Appl. No. 10/604,569
Amdt. Dated 11/30/2004
Reply to Office action of 11/15/2004

Amendments to the Drawings

Figure 1

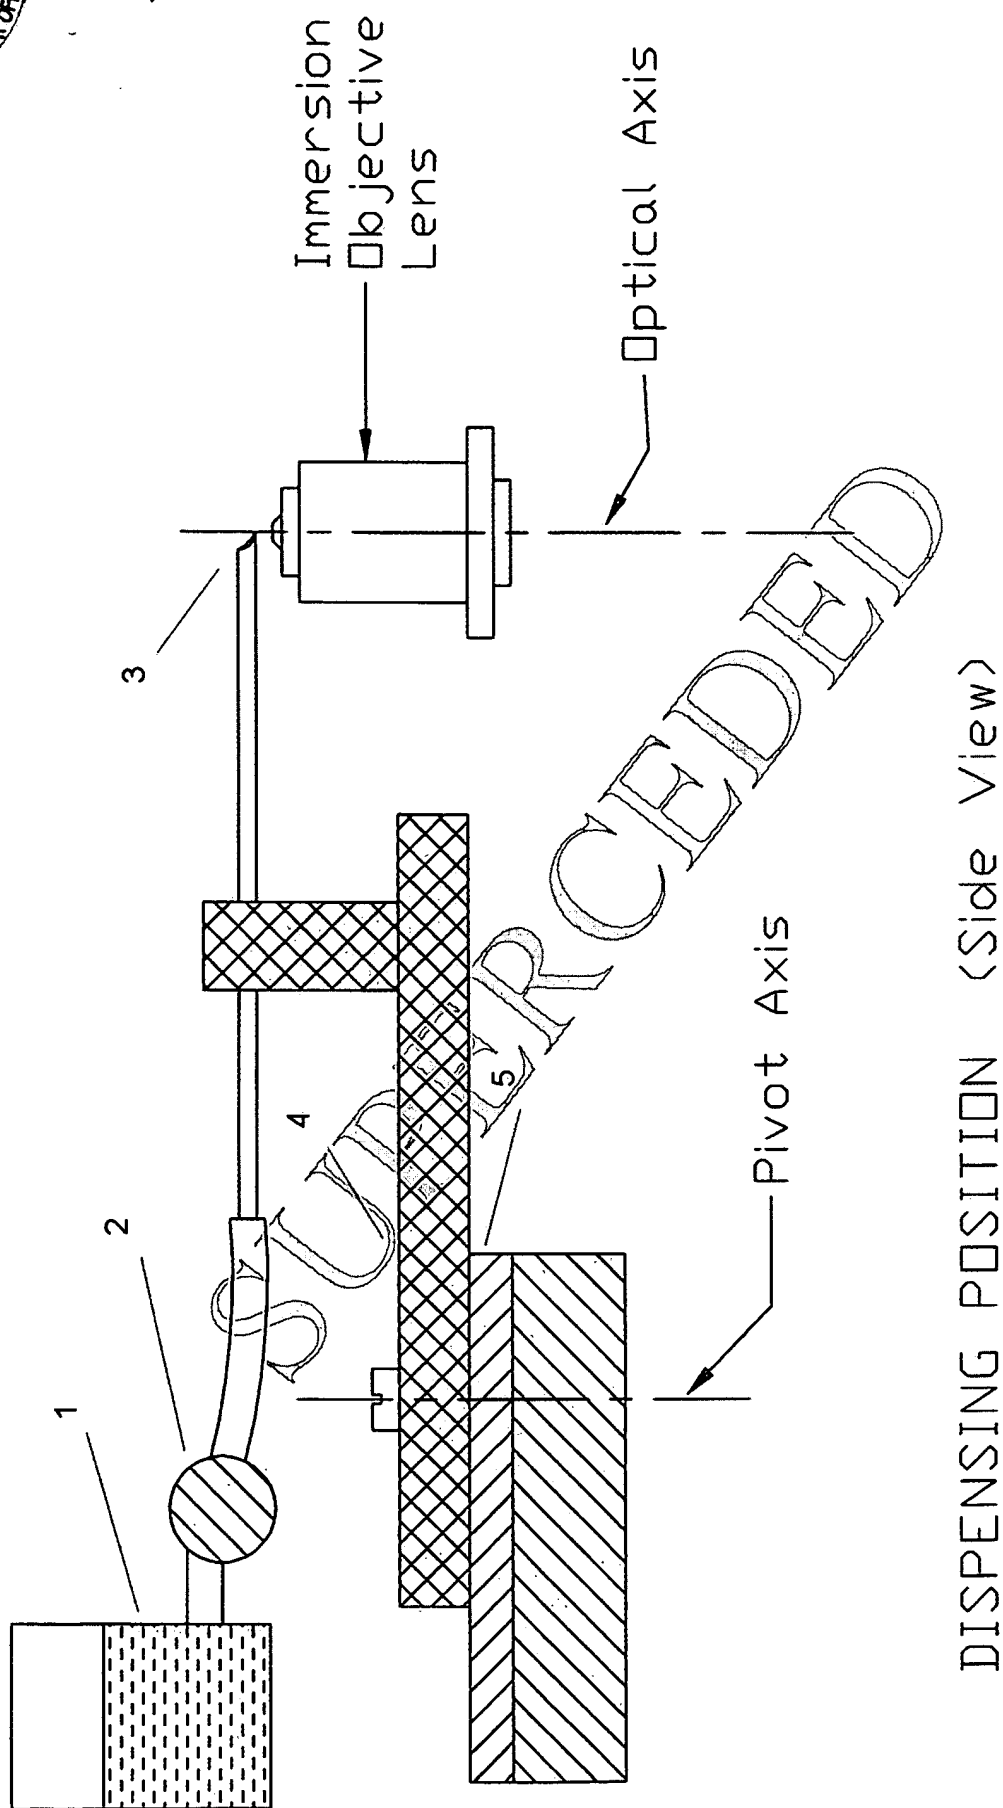
The following figure is a replacement for Figure 1 of the application. This figure has been revised to include the coaxial vacuum channel.
